# APPENDIX D PUBLIC AND AGENCY COMMENTS

## I. Public and Agency Comments

NYS ROUTE 5 (BUFFALO SKYWAY) PROJECT

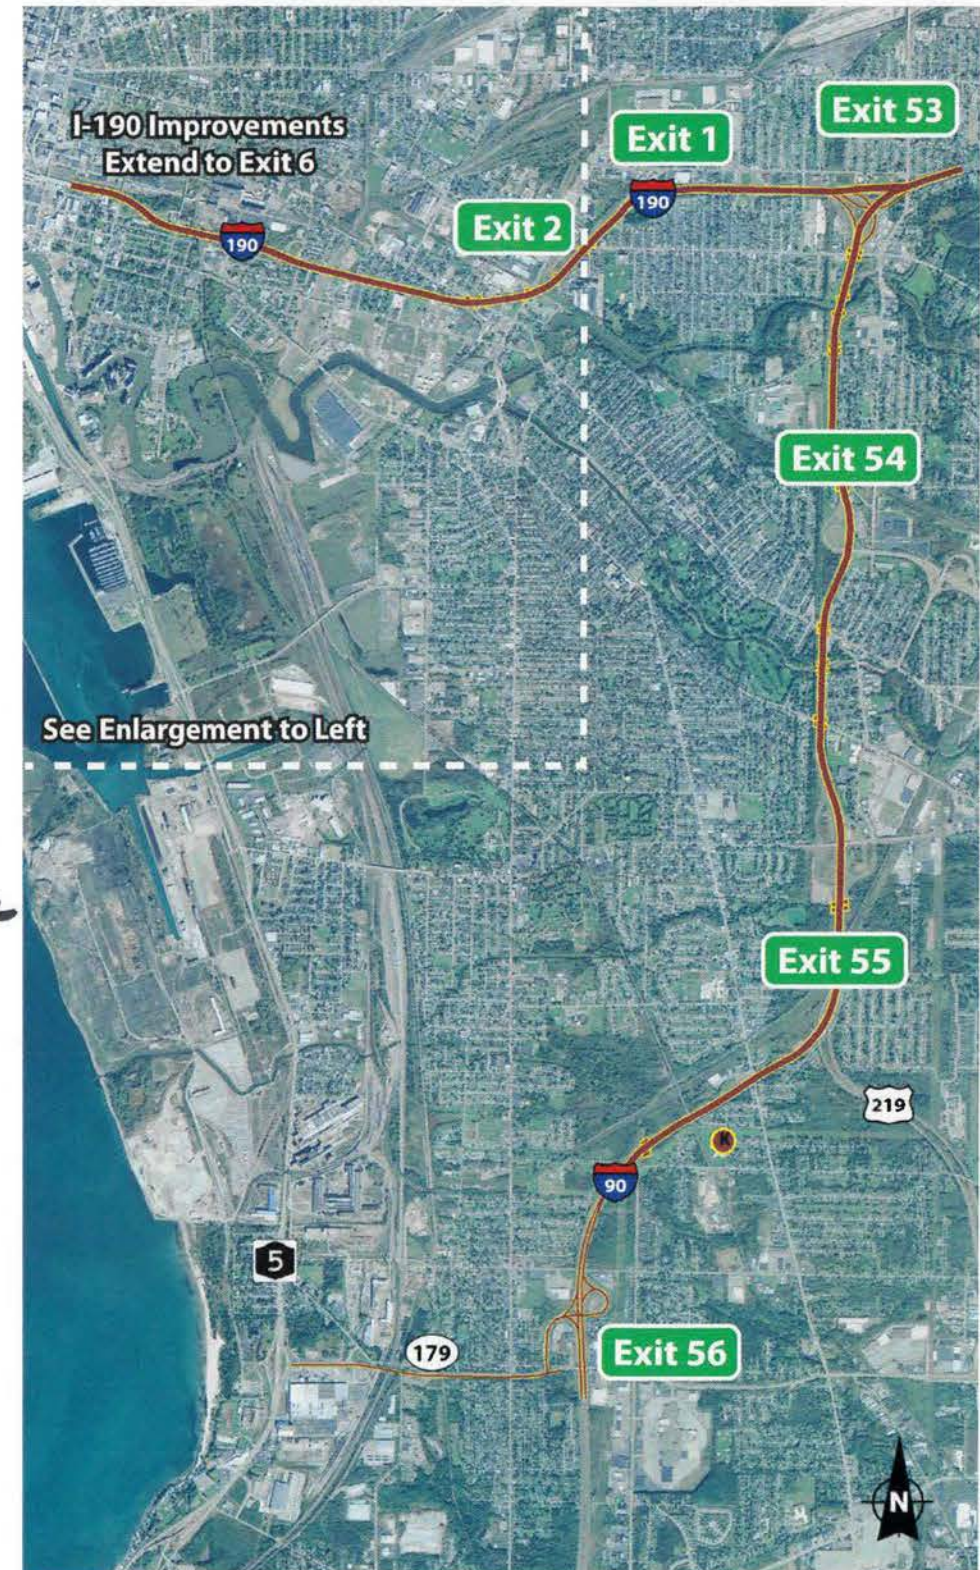
A hybrid between No. 1, 13, 11, 6 was considered by our team

There is no advantage to this(s) alternative(s). The green (no. 11) will require ramps at South Park, Elk and Rt. 90.

# CONCEPT UNDER CONSIDERATION: SKYWAY REMOVAL WITH IMPROVEMENTS TO EXISTING STREETS / INTERSECTIONS

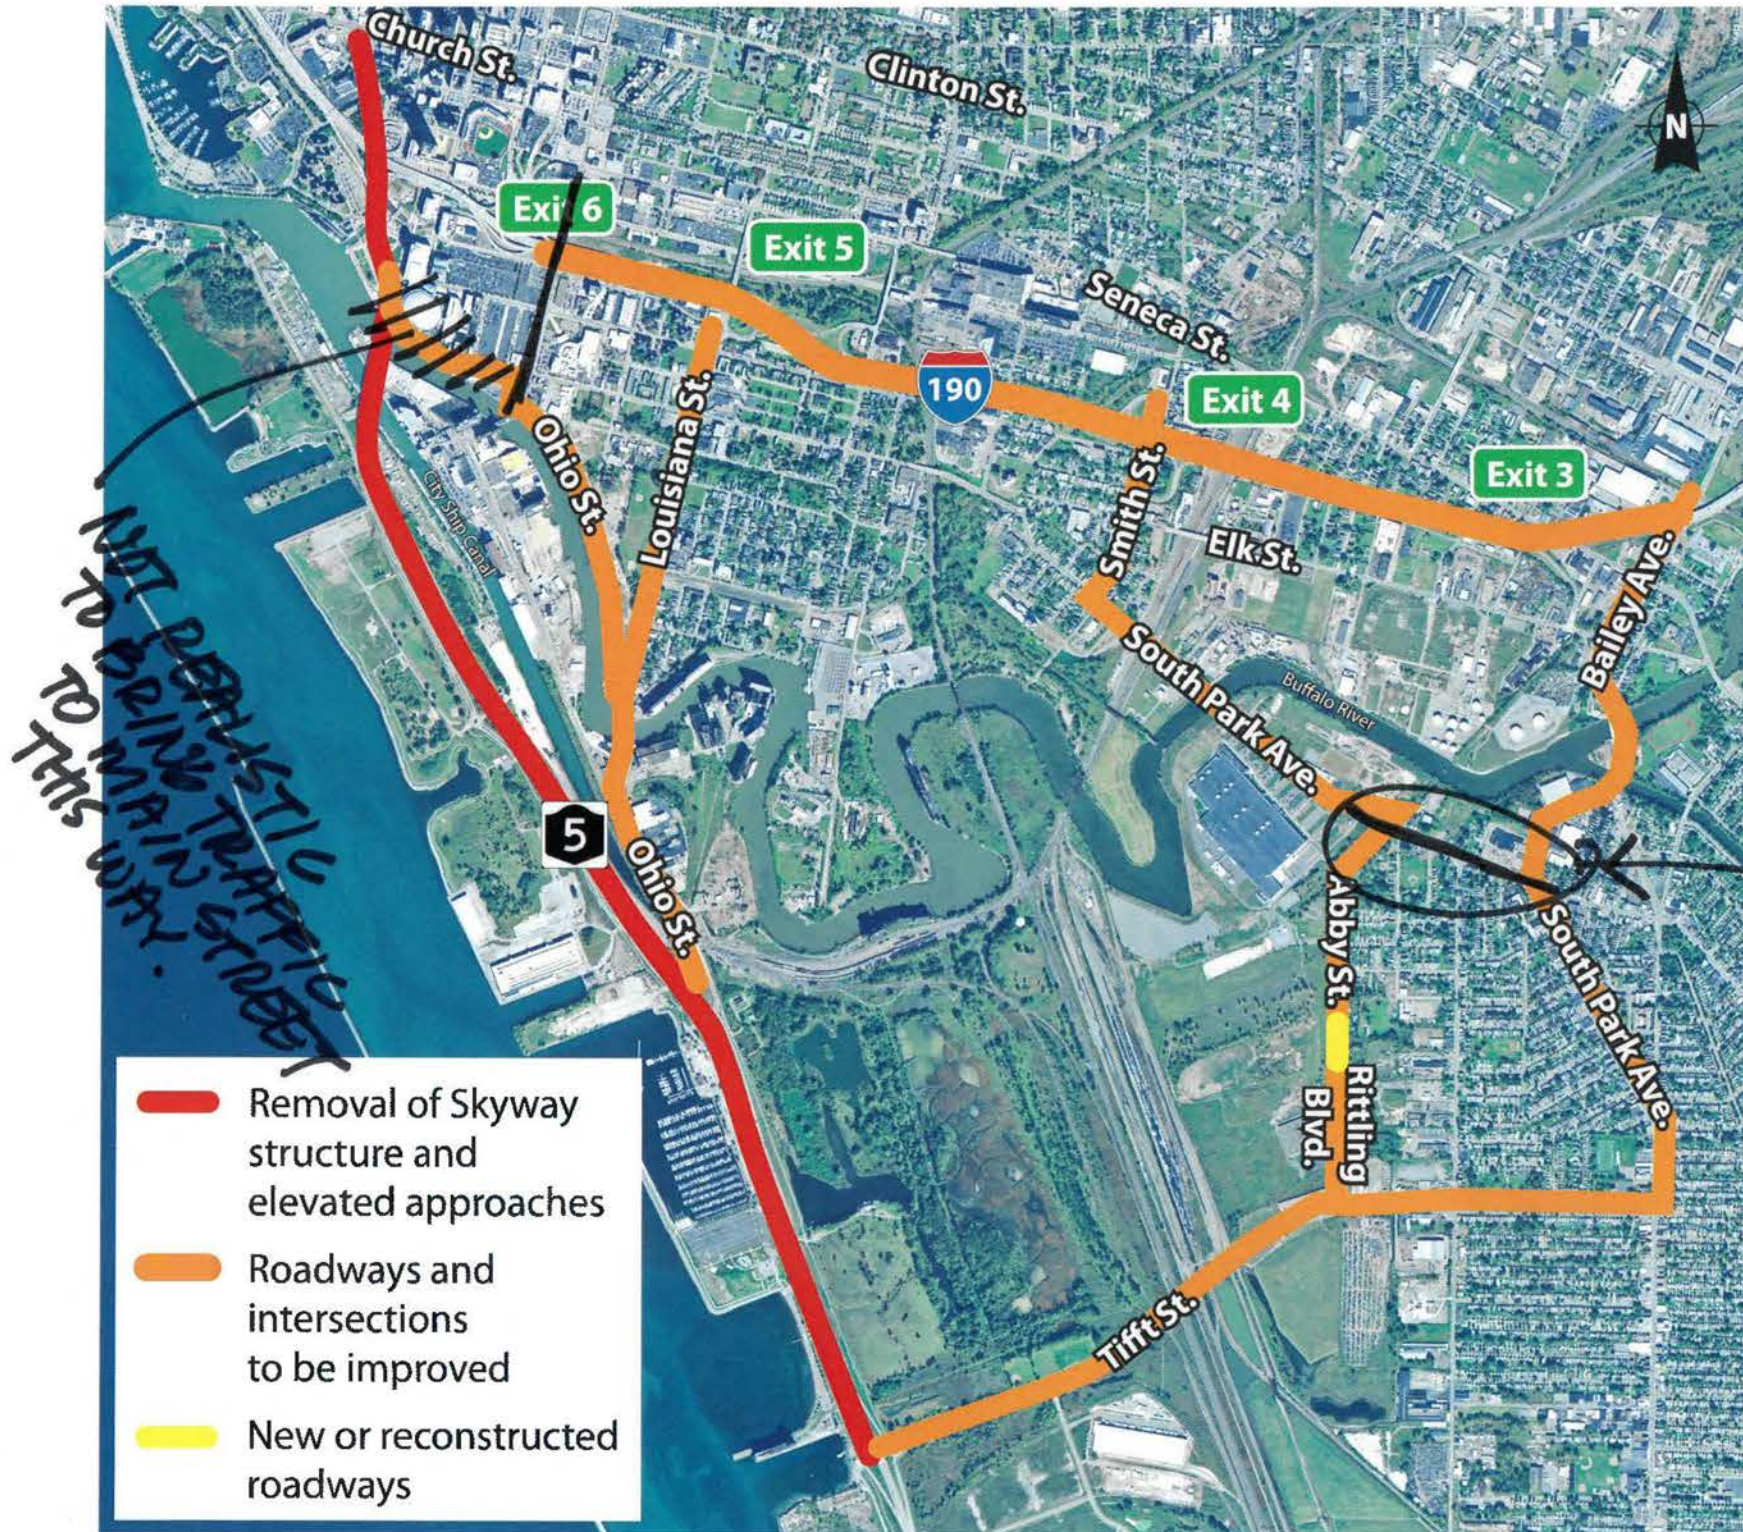
*Good Alternative*

# CONCEPT UNDER CONSIDERATION: SKYWAY REMOVAL WITH NEW TIFFT STREET ARTERIAL

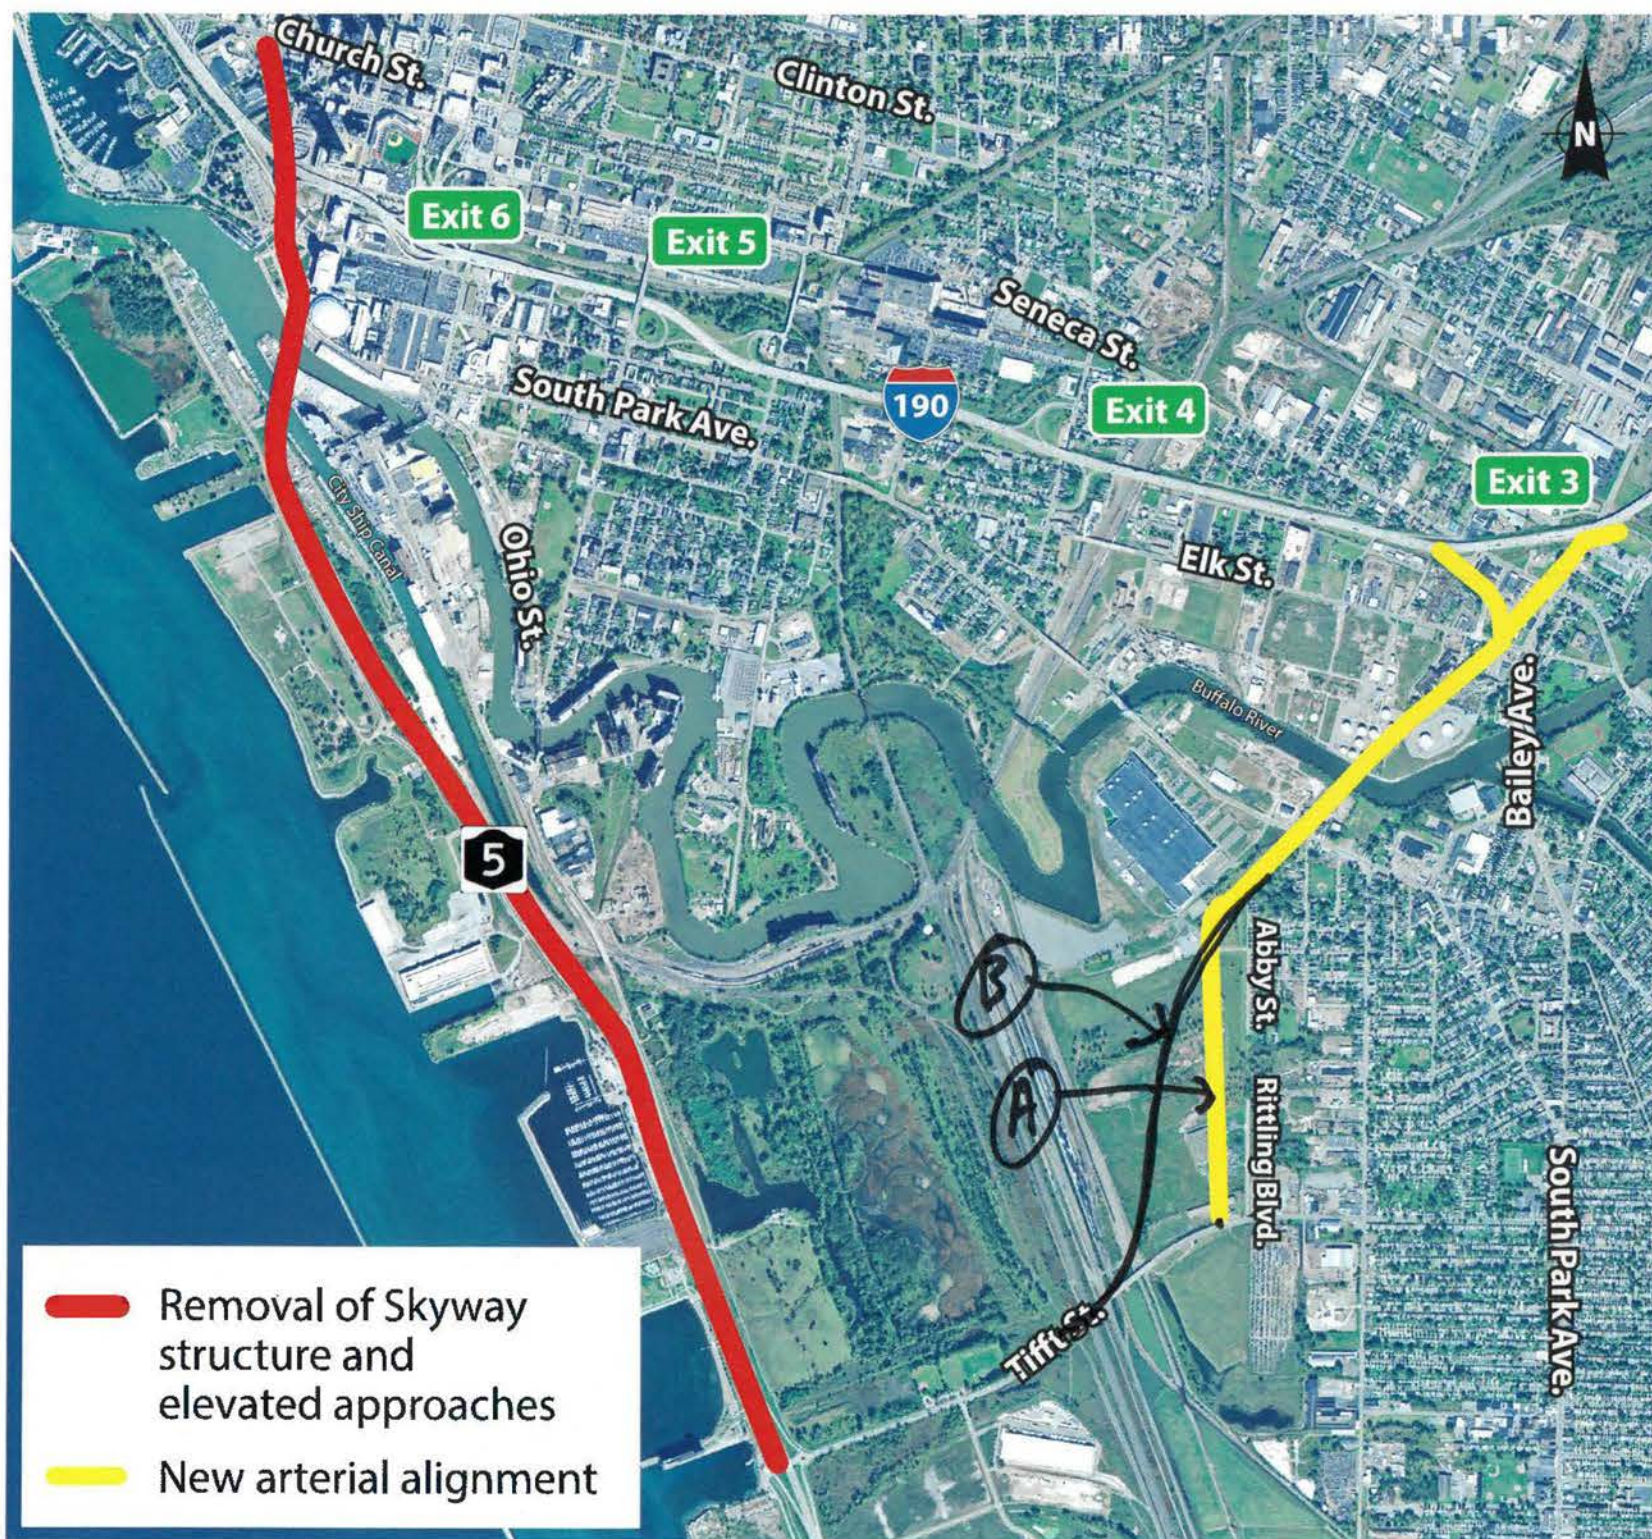
*We proposed something similar, as did Wendel in previous study. Should work with other improvements.*

# CONCEPT UNDER CONSIDERATION: SKYWAY REMOVAL WITH NEW HIGHWAY CONNECTING NYS ROUTE 5 TO I-190

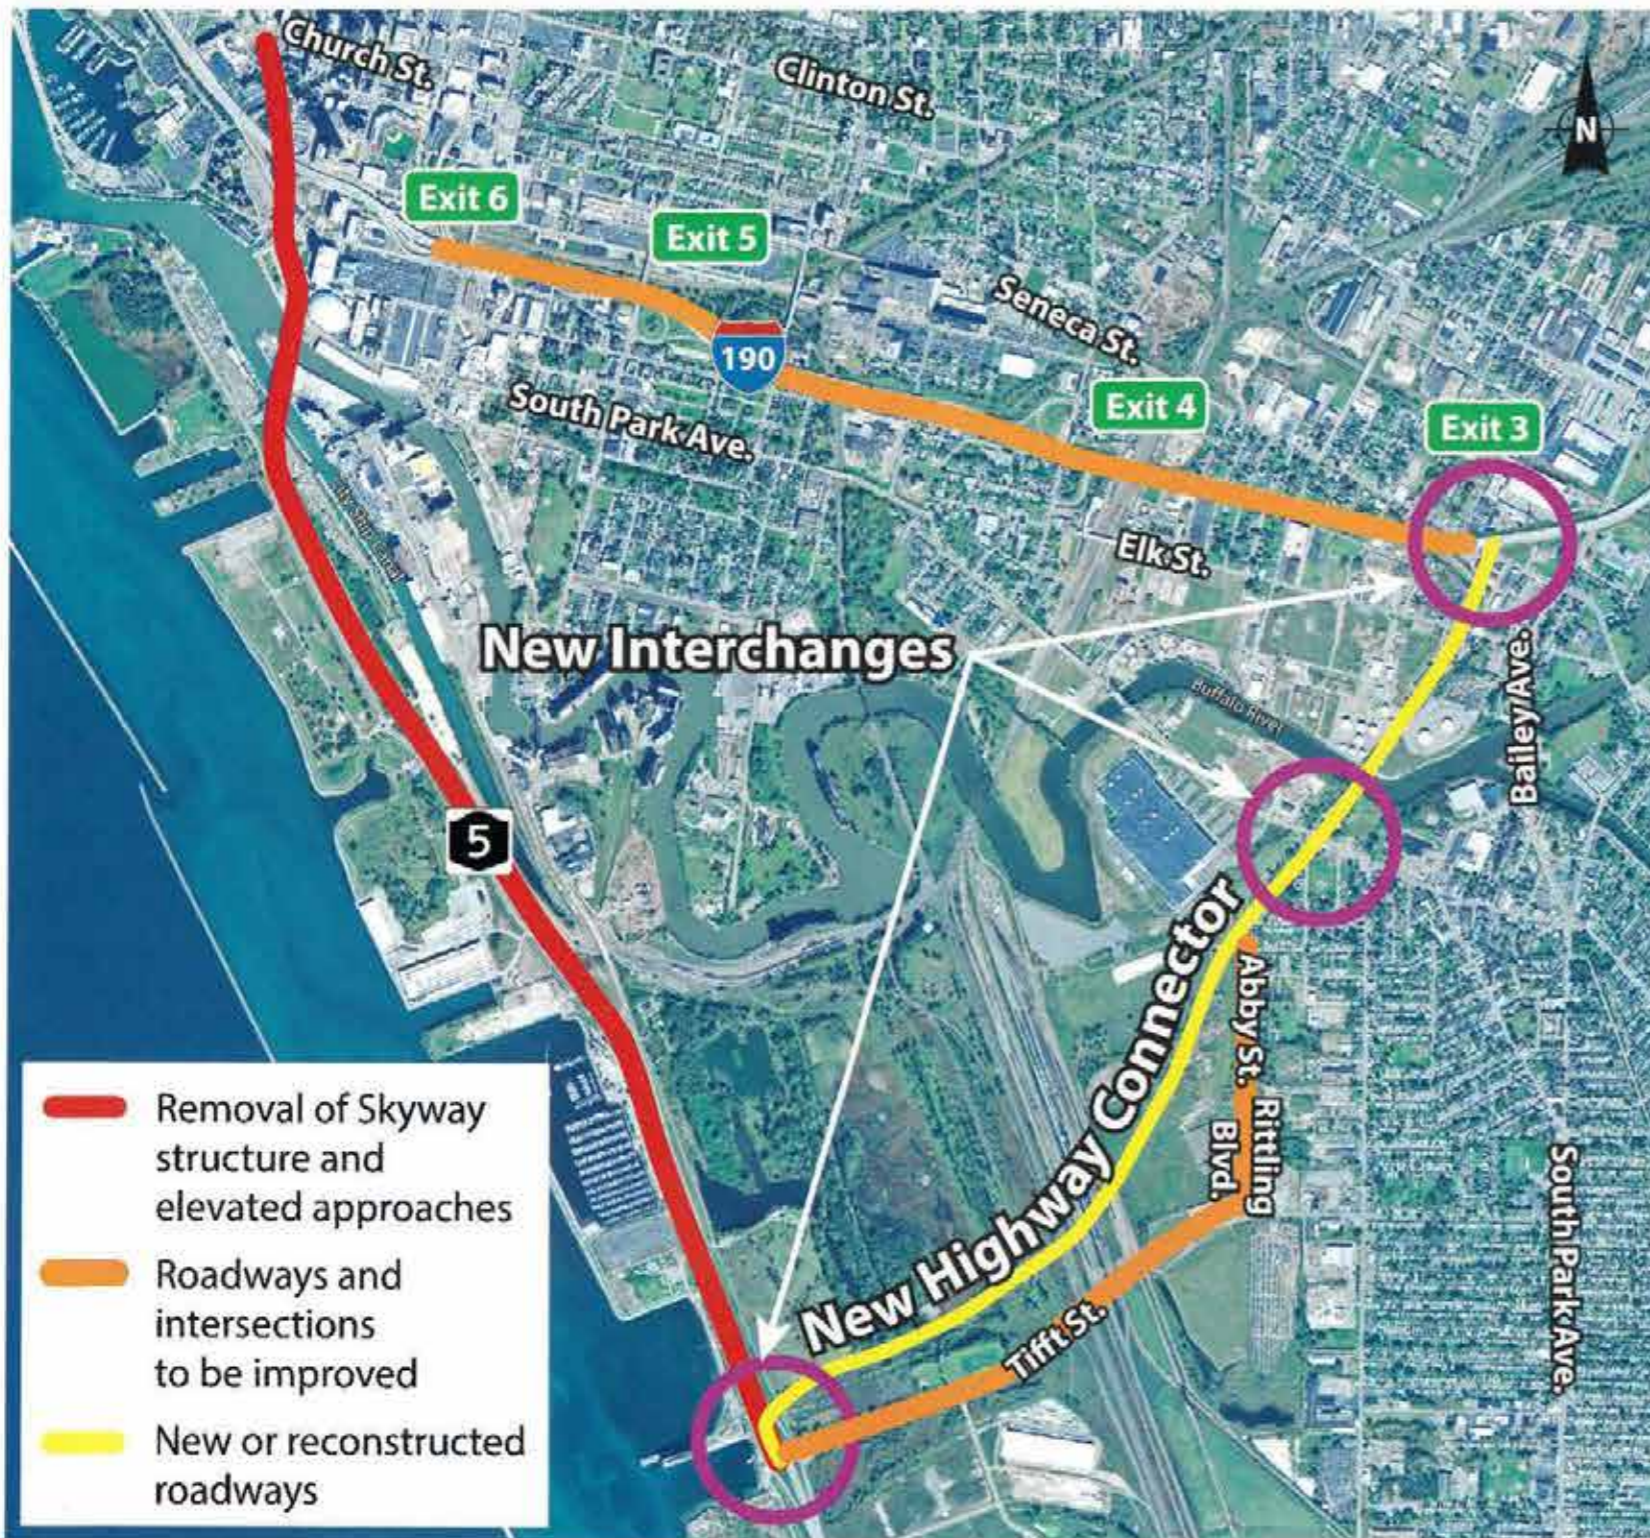
JUST MOVES HIGHWAY BARRIER FROM ONE SPOT TO ANOTHER. IGNORES NEIGHBORHOOD AND ONLY SOLVES COMMUTER ISSUE.
